Re: LC 66 – Portland General Electric Company’s 2016 Integrated Resource Plan (IRP)

PORTLAND GENERAL ELECTRIC COMPANY'S

Reply Comments

FIGURE 1: PGE’S PROJECTED REC BANK (2018-2050)

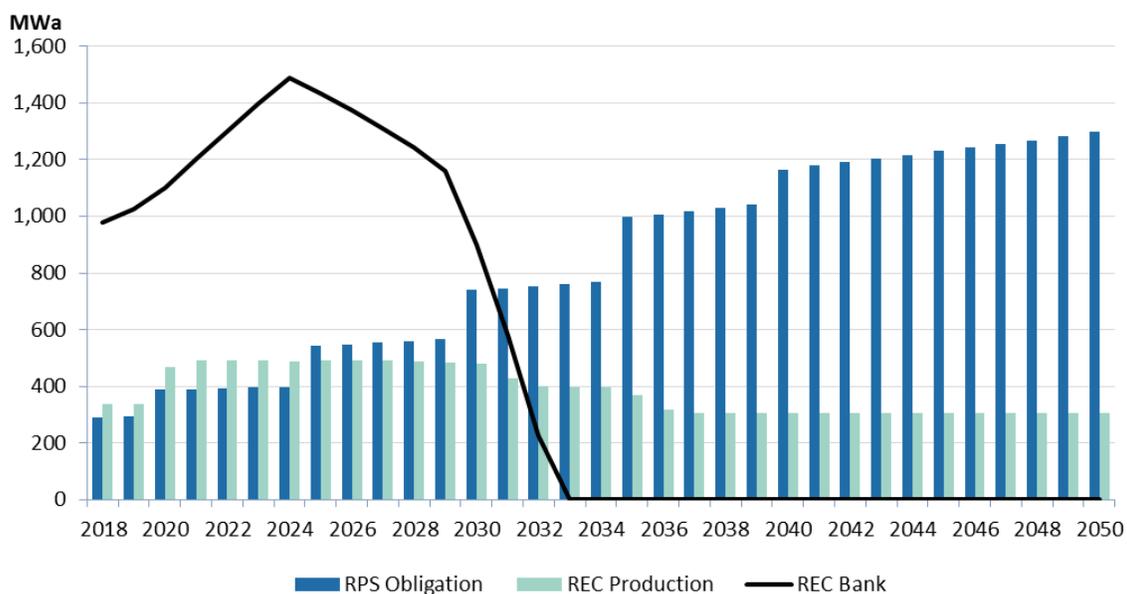
1. **PGE’s use of banked RECs relative to generated RECs for RPS compliance.** PGE addressed Staff’s questions regarding this topic in its response to OPUC Data Request No. 149, in which it provided the following figure (Figure 1) showing an updated version of PGE’s projected REC bank graphic, using the data included in the IRP Update.
